City of Lee's Summit

RE: **Continued Public Hearing #PL2019-071 – PRELIMINARY DEVELOPMENT PLAN – Paragon Star Village, approximately 36 acres generally located at the northeast corner of NW View High Dr. and I-470 Hwy; Paragon Star, LLC, applicant**

3. NORTH ELEVATION @ PARAGON PARKWAY RETAIL / OFFICE

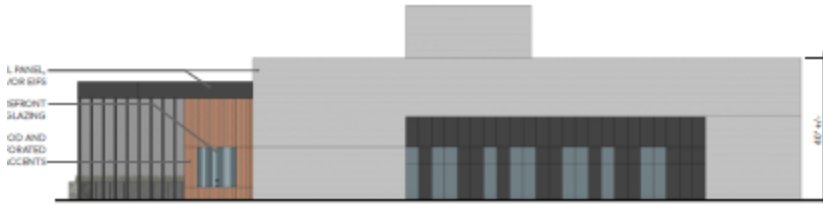
- 2-stories, 40'-height
- 35,000 sq. ft. retail/restaurant -1st floor
- 35,000 sq. f t. office -2nd floor
